US-APWR DCD Tier 1 Enhancement Project

Thursday 2/17/11 Afternoon Handout No. 1

Tier 1 Changes Explanation/Basis Document
Tier 1, Section 2.7.1.1

Figure 2.7.1.2-1 Main Steam Supply System

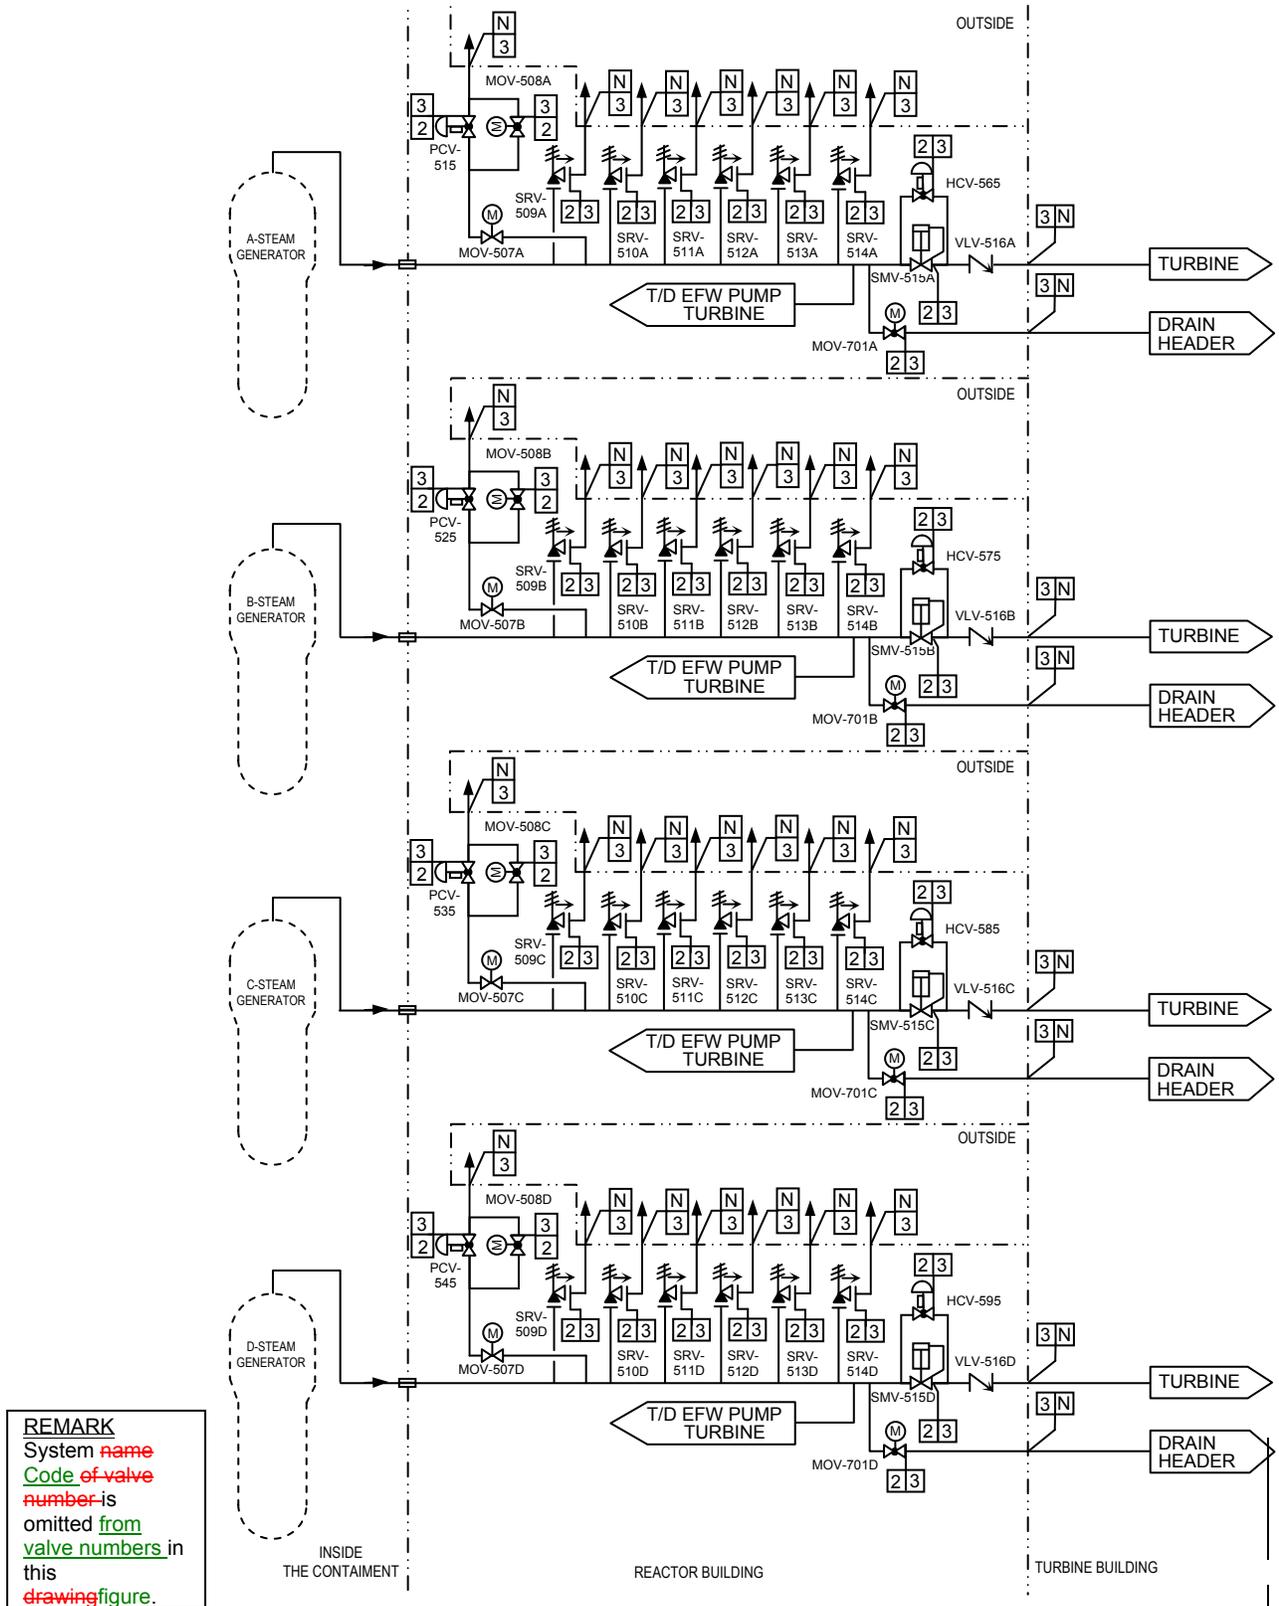
13.b.ii	ITA, AC Enhance clarity [RIS p5, Logic, seventh bullet]
14	ITA, AC Enhance clarity [RIS p5, Logic, seventh bullet]
FIGURE 2.7.1.2-1 Revised the “REMARK” text for consistency and clarity.

Figure 2.7.1.9-1 Feedwater System

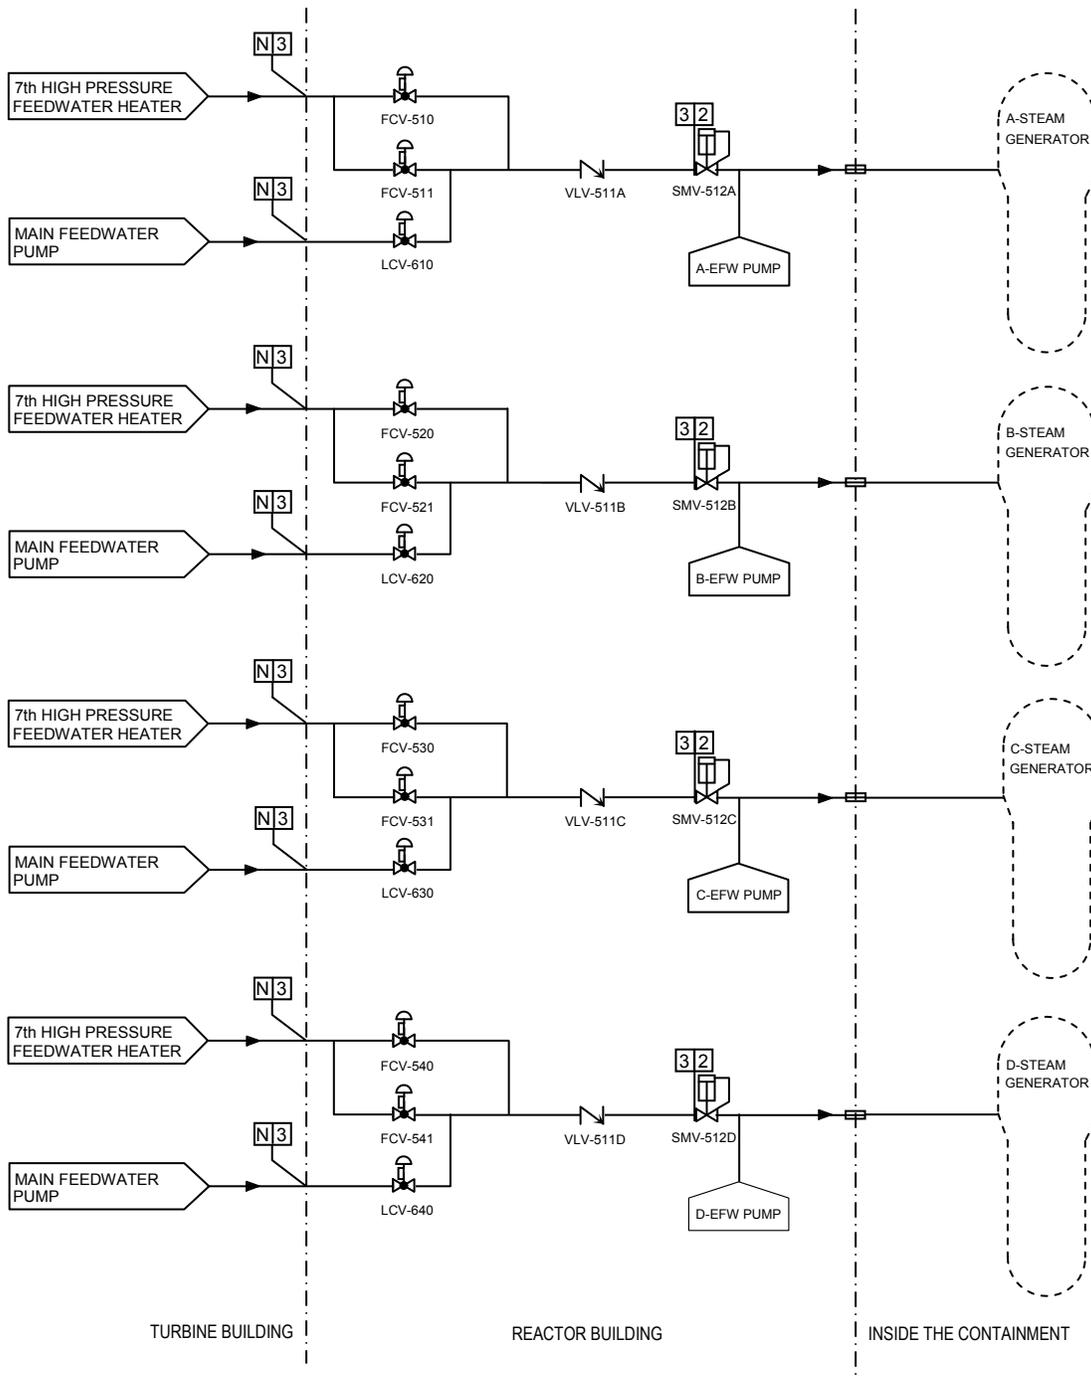
REMARK
 System name Code is omitted
 from of valve numbers is omitted in
 this drawing figure.
 EWS ### +

Figure 2.7.1.10-1 Steam Generator Blowdown System

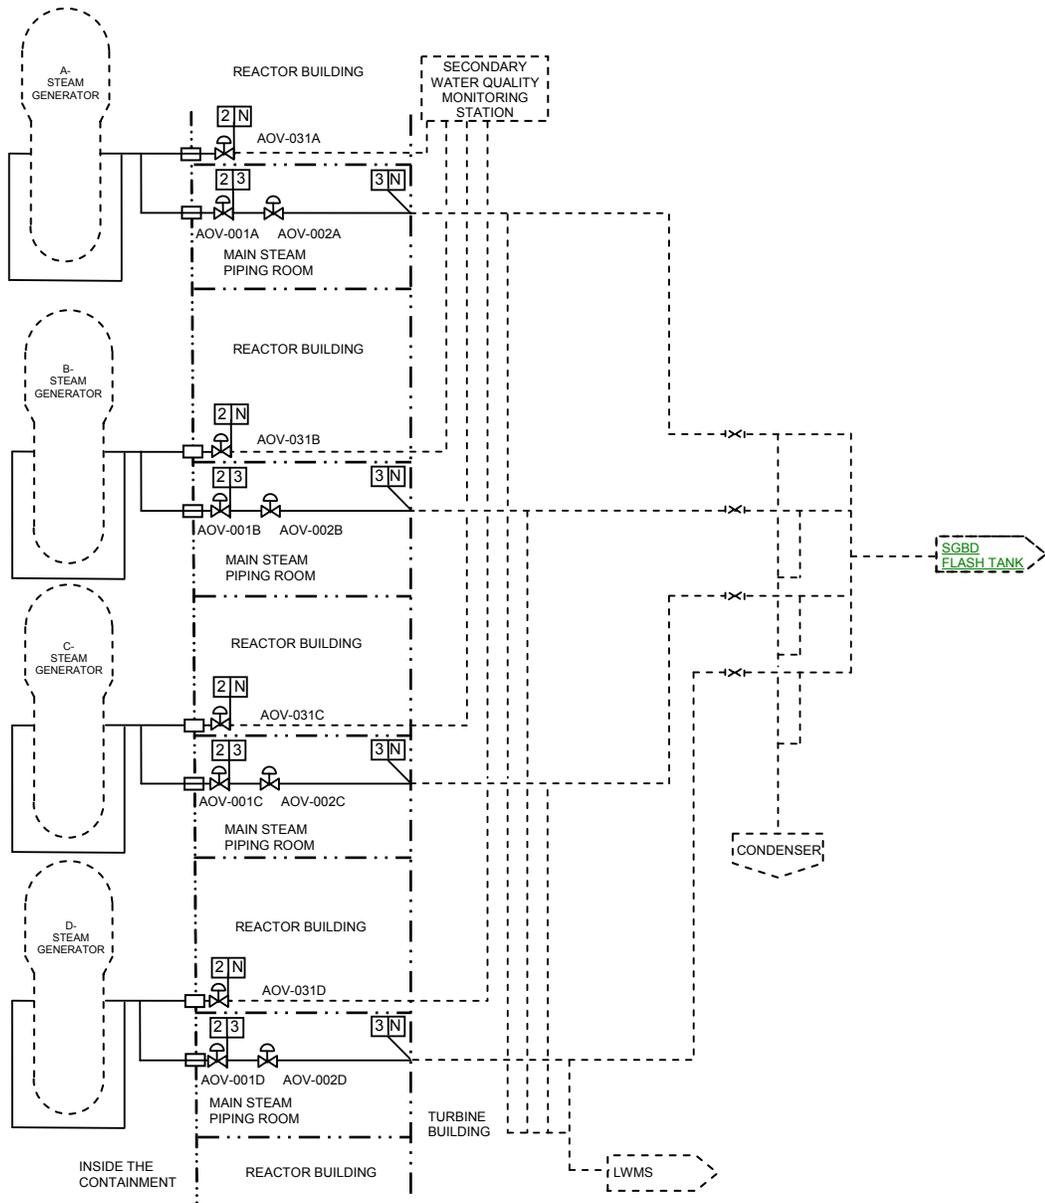
13.b	<p>DC</p> <ul style="list-style-type: none"> - Changes made to align with generic wording for MCR controls ITAAC to provide clarity and consistency. [RIS p7, Scope, second bullet]
14	<p>DC, ITA, and AC</p> <ul style="list-style-type: none"> - Changes made to align with generic wording for MOVs ITAAC to provide clarity and consistency. [RIS p7, Scope, second bullet]
Figure 2.7.1.10-1	
Figure is revised to depict necessary attributes to be verified by functional arrangement ITAAC. (Non-safety portion: Dashed line, discharge line of SGBD flash tank is simplified.). The “remark” box wording is modified for editorial purposes.

REMARK
 System name-Code of in-valve numbers is omitted from valve numbers in this drawing figure.
 SCS ###-+++
